# UNITED STATES PATENT AND TRADEMARK OFFICE

APPLICATION NO.	FILING DATE	FIRST NAMED INVENTOR	ATTORNEY DOCKET NO.	CONFIRMATION NO.
10/065,715	11/13/2002	Kuo-Chin Huang	OTMP0031USA	4267
27765	7590	05/18/2004	EXAMINER	
NAIPO (NORTH AMERICA INTERNATIONAL PATENT OFFICE) P.O. BOX 506 MERRIFIELD, VA 22116			GARCIA, ERNESTO	
			ART UNIT	PAPER NUMBER

## **DETAILED ACTION**

FIG. 2

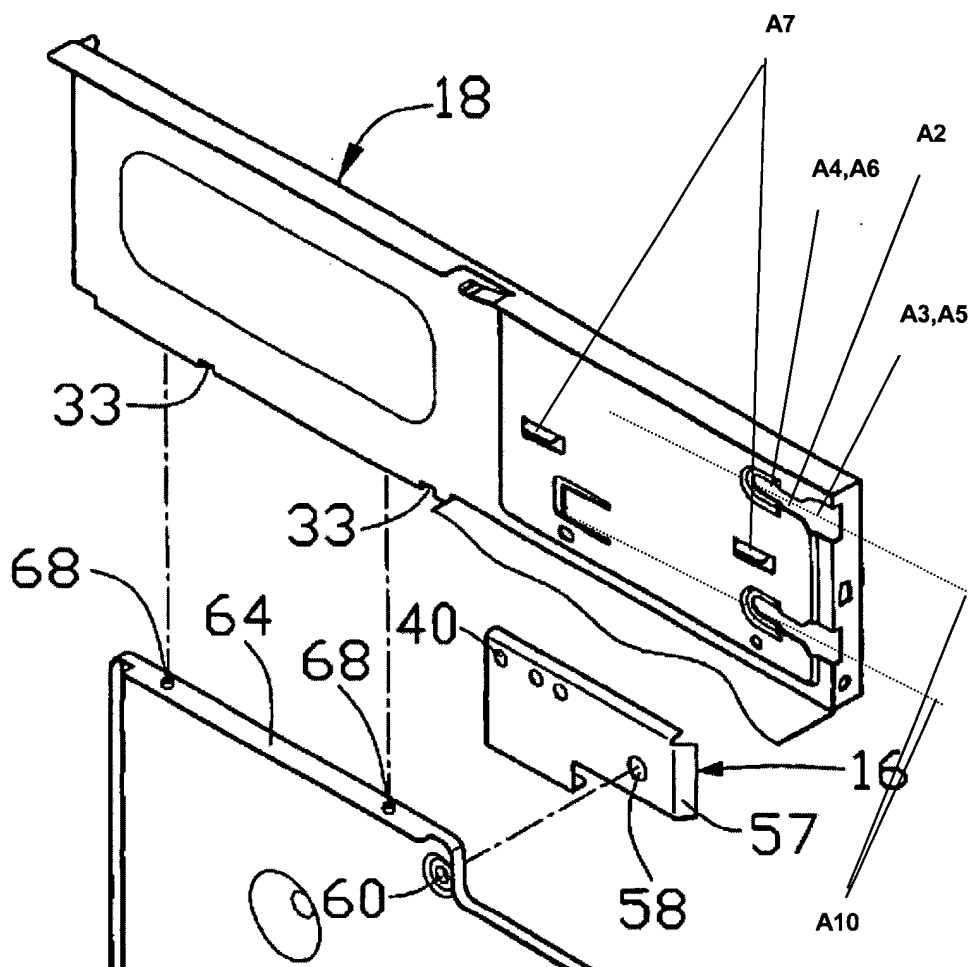
Claims 1, 3 and 5 are rejected under 35 U.S.C. 102(b) as being anticipated by Liao, 6,239,978 (see marked-up attachment).

Regarding claim 1, Liao discloses, in Figure 2, a chute positioning apparatus comprising a positioning board **18**, chutes **A2**, and guide boards **A7**. The chutes **A2** are formed in the positioning board **18**. At least one of the chutes **A2** has a loading-and-unloading section **A3** and a tightening section **A4**. An opening **A5** of the loading-and-unloading section **A3** is greater than an opening **A6** of the tightening section **A4**. The guide boards **A7** are vertically mounted on the positioning board **18** and the guide boards **A7** externally protrude to form a guide surface.

Regarding claim 3, the chutes **A2** are on two contour lines **A10** of a top side **A11** and a bottom side **A12** of the positioning board **18**.

Regarding claim 5, the positioning board **18** is able to form on a main device.
